City of Durham Trust – Objection

DM/20/03558/OUT Land To The East Of Regents Court Sherburn Road Durham

Proposed residential development of up to 440 dwellings (outline including access).

Proposed design for Bent House Lane junction

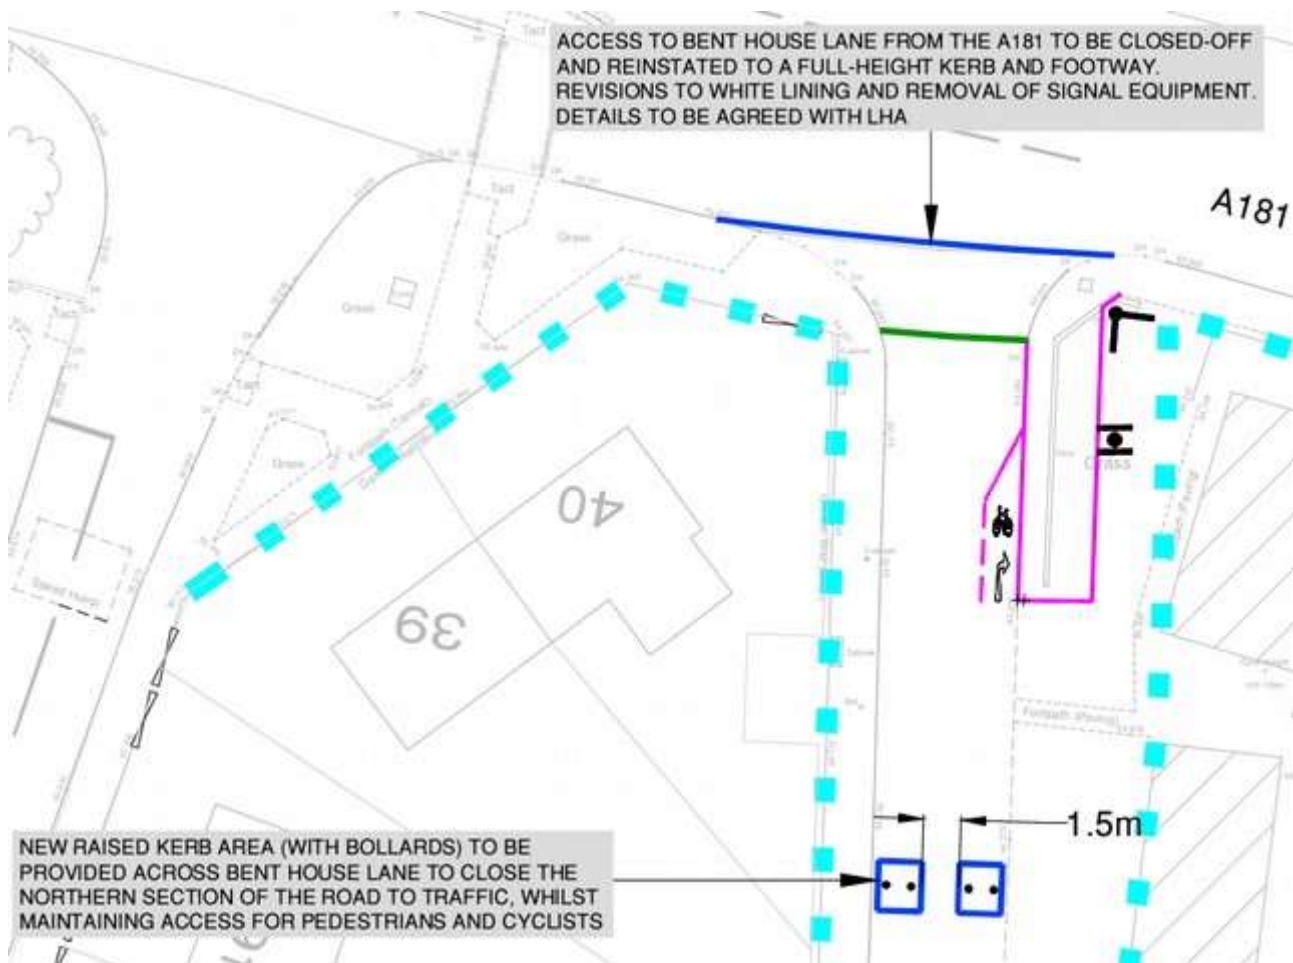
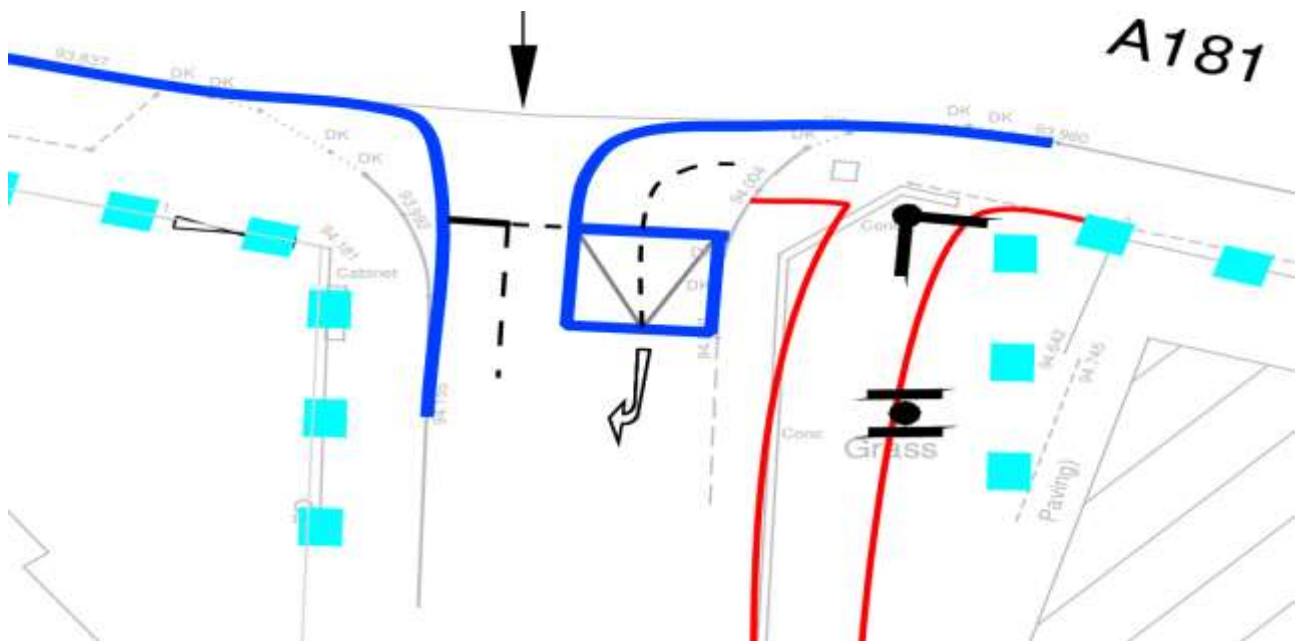
The drawings show the north end of the lane blocked up and a new kerb line linking the A181 footways on either side of the lane. Access via a dropped kerb on the right hand side of the road would allow cyclists to join the pavement and proceed eastwards along the A181 towards the new junction with Damson Way. This footway was recently improved and designated for shared pedestrian and cycle use.

Actually, the drawing is already out of date, because the County Council recently provided better access to the A181 shared use path from further south:

For users approaching the junction from the east along the A181, the Council's design caters only for those turning south down Bent House Lane. There also needs to be provision for cyclists to continue along the A181 towards the city centre, or to turn right onto Dragon Lane. Once the new housing estate is developed, there will be more people wishing to make these movements. A cycle route from Sherburn Village along the B1283 would also add to the cycle traffic here.

The Trust has two objections to the applicant's proposed design.

The Trust asks that cycle access be maintained at this junction. A design is suggested below. The red lines show the approximate route of the shared use path recently built by the Council.

This small modification to the proposals would preserve the existing cycle network and is the minimum necessary, but the County Council should have a view as to how the changes could contribute to the medium term strategy which would include protected cycle lanes westwards on the A181 and northwards on Dragon Lane, and how the various possible junction movements can be accommodated.

The following excerpt has been annotated to show:

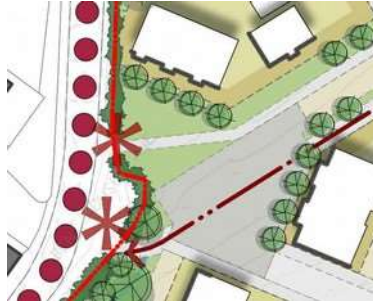
- current route (blue dotted line)
- route sketched in masterplan (red solid line)
- most direct route possible (red dashed line)

Although the proposed diversion is reasonably direct to start with, at the Bent House Lane end, it becomes increasingly indirect towards the Damson Way end as it interacts with the main vehicular access road, the proposed new bus stop, and the change in land ownership.

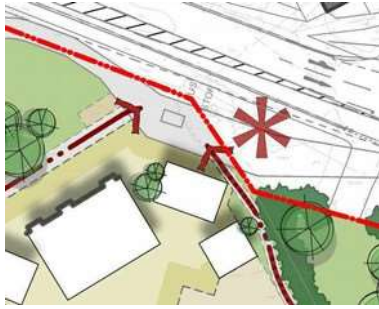
The path starting with an unnecessary bend in the route at the junction with Bent House Lane. To be legible as a main cycling and walking route the path should be straight and obvious.

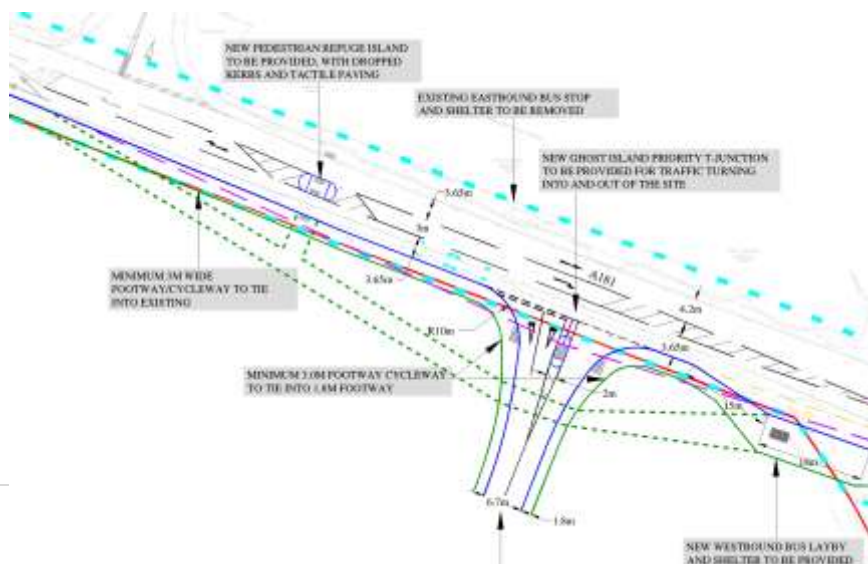
As well as the plan view in the masterplan, the Design and Access Statement (app. 1/11) also shows a sketch (shown below) of where the new link meets Bent House Lane. The yellow dashed line has been added below to highlight the main link from Bent House Lane to Damson Way. For this to be legible as a main route it should be redesigned to make a junction with Bent House Lane which is straight and obvious.

in writing by the Local Planning Authority. The submitted plan shall be in compliance with the LTN 1/20 design guidance for cycle routes and the route shall be separated as far as possible from motor traffic, shall have priority, where appropriate, at any road crossings, and shall not diverge from the most direct alignment unless this is justified for reasons of safety or practicality.

Reason: to give priority to pedestrian and cycle movements and to promote sustainable transport methods in accordance with Policy 21 of the County Durham Plan and Part 9 of the National Planning Policy Framework.

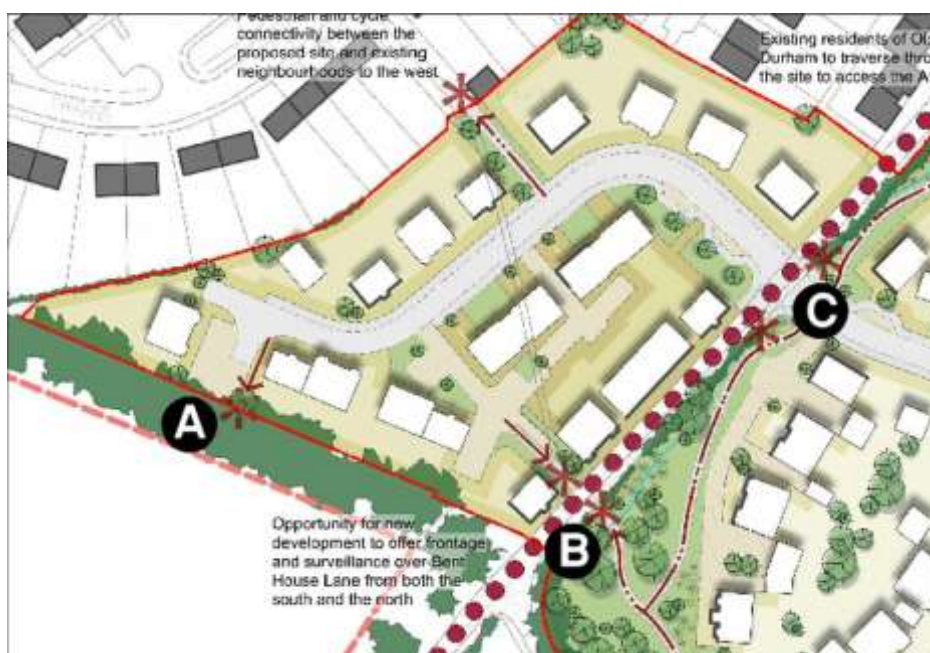
This excerpt (above) from the plans (with vehicle tracking paths removed for clarity) shows the proposed access road with its two-lane exit onto the A181 and with tactile paving and a refuge for use by cyclists and pedestrians.

For all these reasons the Trust asks that the crossing be relocated as indicated approximately by the green dashed lines added to the above diagram. The long tapered approach from the west is designed to minimise the additional distance resulting from the diversion from the desire line. From the east the setting back of the bus stop helps in the transition to the set-back crossing point. The carriageway may need to be widened to accommodate a 3m deep refuge, or, with the increased distance from the junction it may not be necessary to have a refuge, especially if a raised table and give way markings allow pedestrians and cyclists priority. Section 10.5 of LTN 1/20 gives guidance on priority junctions. With sufficient set-back away from the main junction, and low speeds and traffic volumes, the Trust believes this should be possible.

Between the path and the A181 carriageway the new alignment would allow a grass verge to be provided. LTN 1/20 recommends a horizontal separation of at least 0.5m between the carriageway and a cycle track on a 30mph road, or 1m on a 40mph road, so the Trust's proposal would be an improvement on the current shared use path which has no horizontal separation.

This change should not be significantly different in cost from the applicant's proposal: the deviation shown is along that length of the A181 where the existing kerb and footway would have to be excavated to construct the applicant's design. In fact, by constructing the new path first, before the works on the main carriageway, it may be possible to keep a cycle and pedestrian route open throughout the course of the works.
